Meeting: Conservation Commission

RE: 100 Durgin Lane

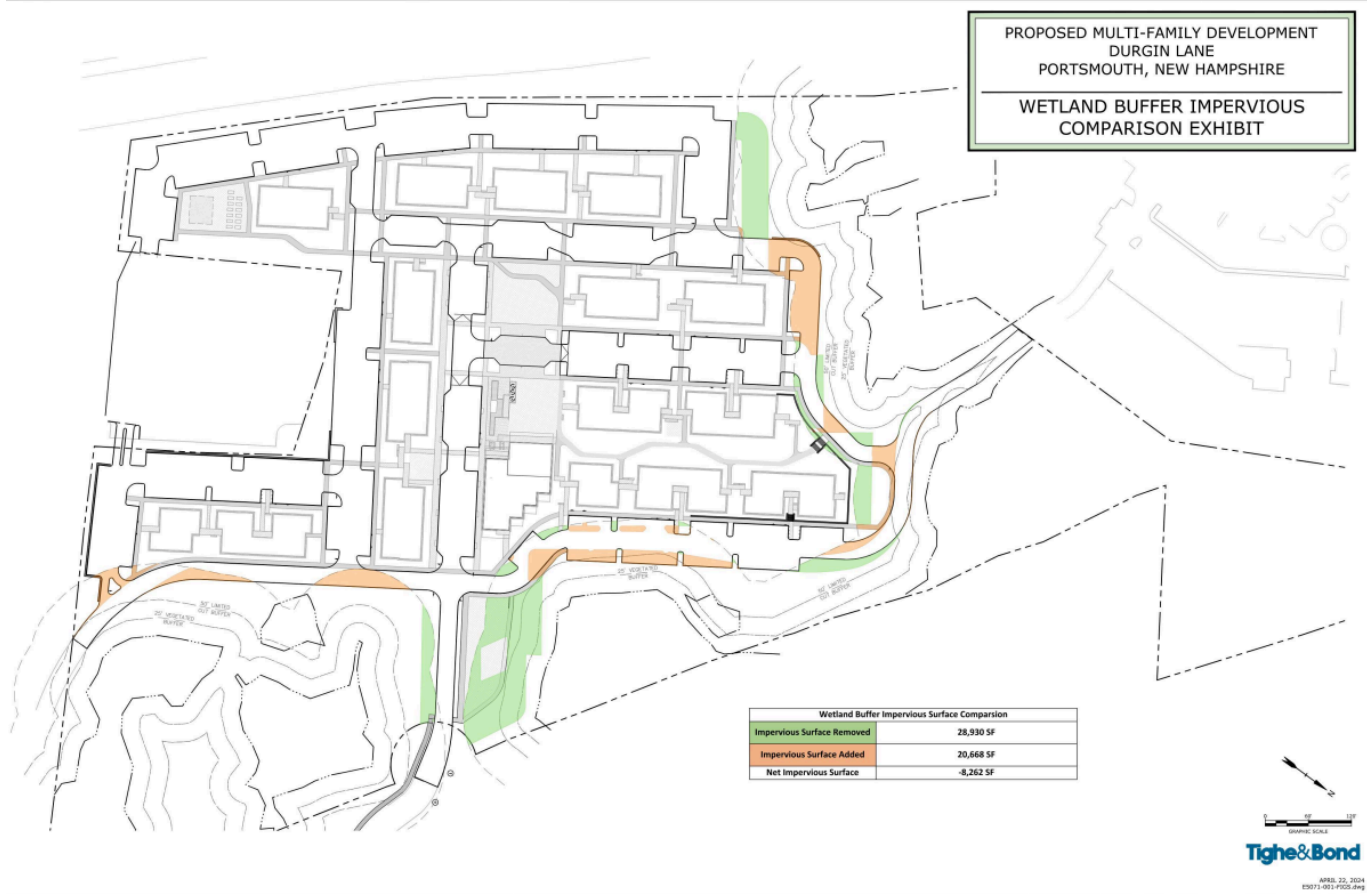
Please do not grant 100 Durgin Lane at Wetland CUP, they do not meet 2,3,4,5,6 of the criteria. The land is suited for what is proposed. The rest of the criteria are not met. The most important part for this application seems to be at the very end, Wetland Delineation Report on pages 175 to 189. The least impactful design plan has not been presented.

Looking at page 118 of the application, below, it is currently a large building with a very large parking lot. *An overlay graphic of what is being proposed and what currently exists could be helpful in assessing how the wetlands will be impacted.* It is true they are adding more greenspace to the lot but looking at Impervious Surface Comparison (below-page 189), one can see the cost for that greenspace involves adding parking and a road into the wetlands as well as a retaining wall.
